HISTORIC AND DESIGN REVIEW COMMISSION

November 20, 2024

HDRC CASE NO: 2024-323
ADDRESS: 509 MADISON ST
LEGAL DESCRIPTION: NCB 749 BLK 8 LOT 3 EXC N IRR 7.13 FT AND EXC W IRR 2.5 FT
ZONING: RM-4, H, RIO-4
CITY COUNCIL DIST.: 1
DISTRICT: King William Historic District
APPLICANT: Christopher Rocha/Master Contracting
OWNER: BICOASTAL VENTURES LLC
TYPE OF WORK: Carport Construction
APPLICATION RECEIVED: September 12, 2024
60-DAY REVIEW: November 11, 2024
CASE MANAGER: Caitlin Brown-Clancy

The applicant is requesting a Certificate of Appropriateness for approval to construct a detached carport along the Northern side of the property over the existing driveway. The applicant has proposed two options for consideration. Option 1 is a hipped roof standing seam carport with columns. Option 2 is a cantilevered mono-pitch carport with aluminum framing and polycarbonate corrugated panels.

SHEET TITLE:
SITE PLAN

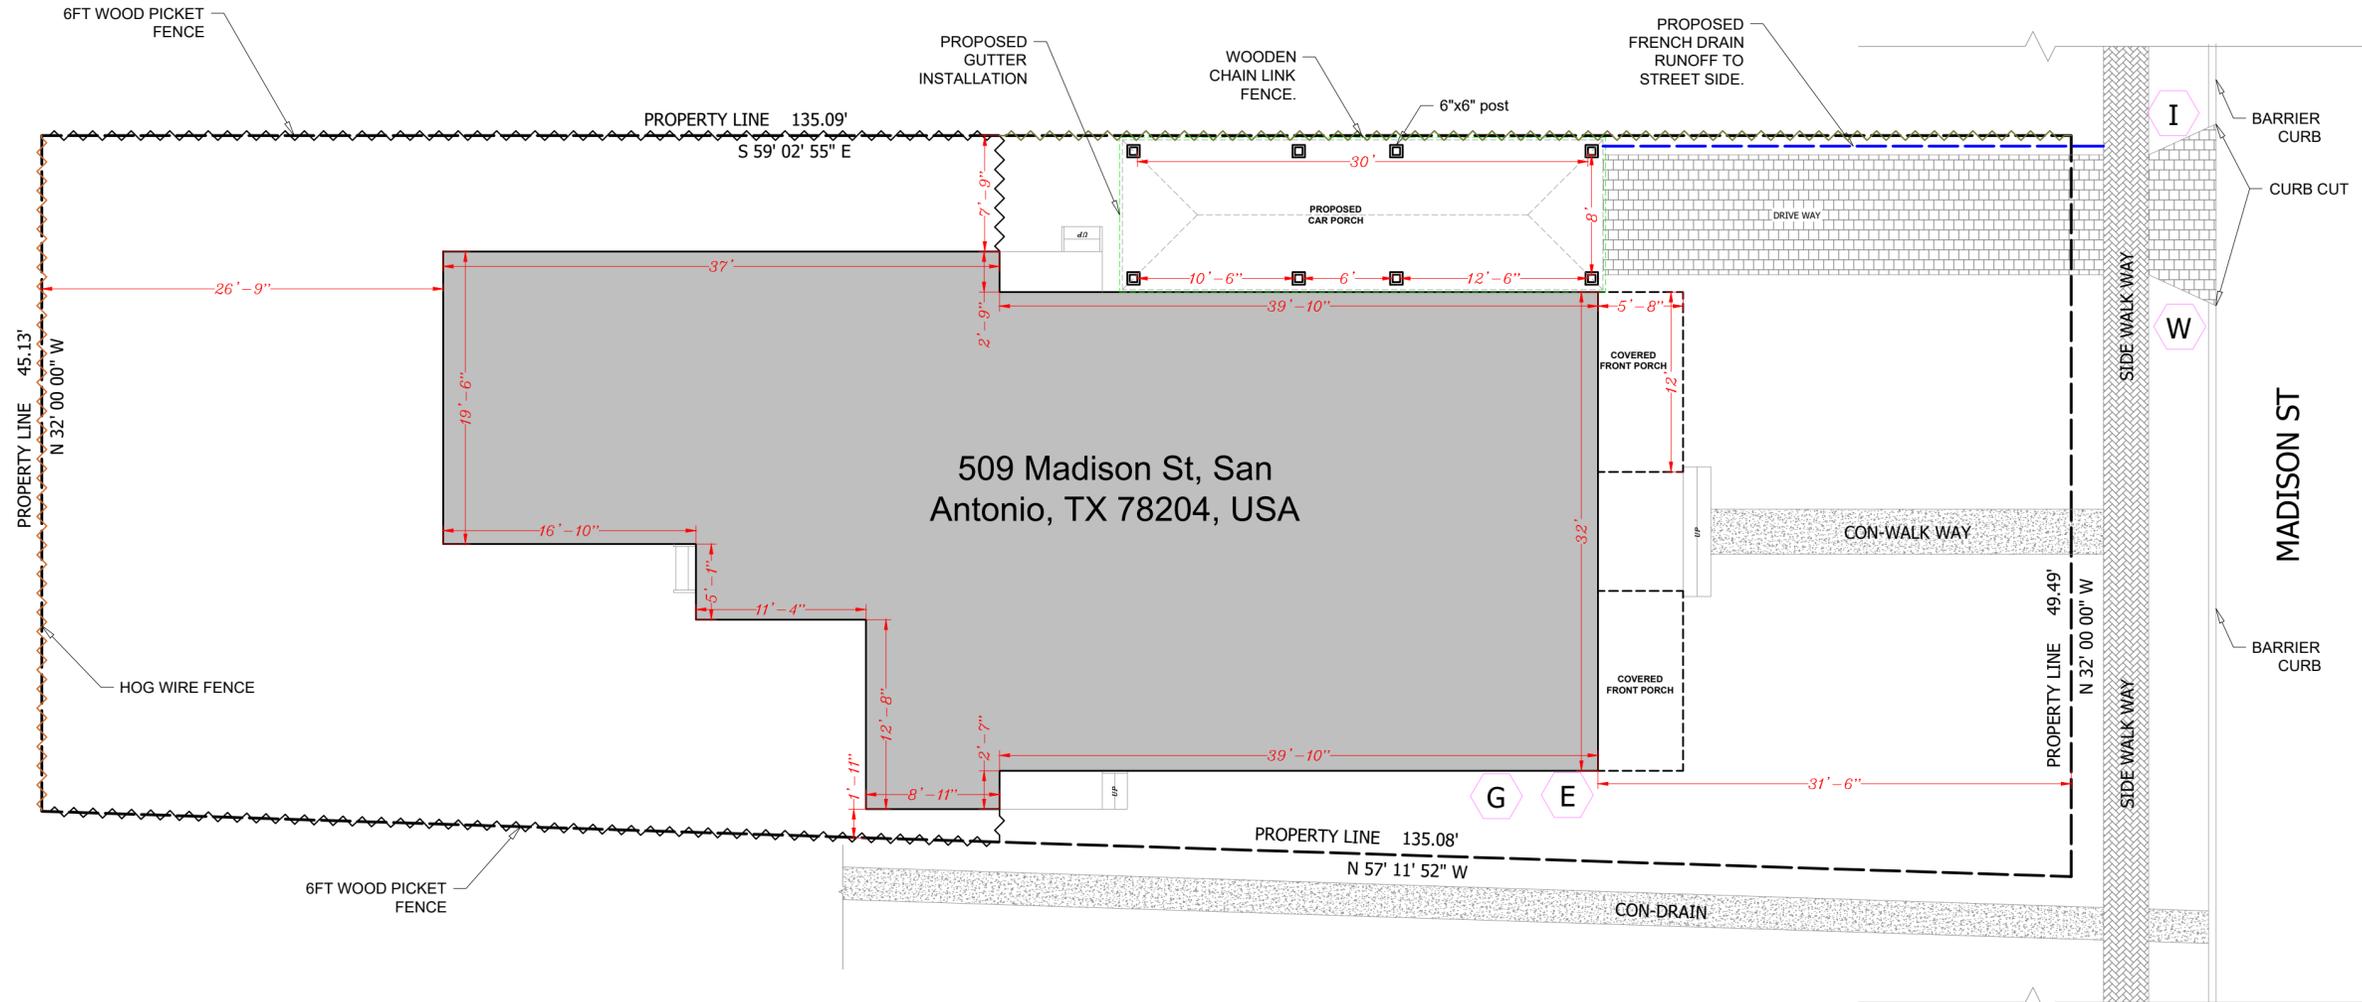
CARPOR: SETBACKS – The applicant has submitted drawings proposing two separate setbacks to for the new accessory structure. Guideline 5.B.ii for new construction stipulates that new garages and outbuildings should follow the historic orientation and setbacks common in the district. The applicant is responsible for complying with all zoning setback standards and filing for a variance with the Board of Adjustment if applicable. Staff finds the carport should be set back fully behind the front wall plan of the primary structure in order to conform to the Guidelines. Staff additionally finds a carport that encroaches into the side yard at this location is not appropriate because there is no precedent for a non-conforming structure at this location.

Staff does not recommend either carport option at this location based on the findings. If the HDRC finds that a carport is appropriate, staff recommends the following stipulations be considered.

- I. The freestanding, wood construction carport design is preferred over the metal option.
- II. That the carport be set behind the front façade wall plane and reduced in length to accomplish this stipulation.
- III. That fully dimensioned and to-scale drawings that meet the stipulations be submitted to staff to receive a Certificate of Appropriateness (COA).
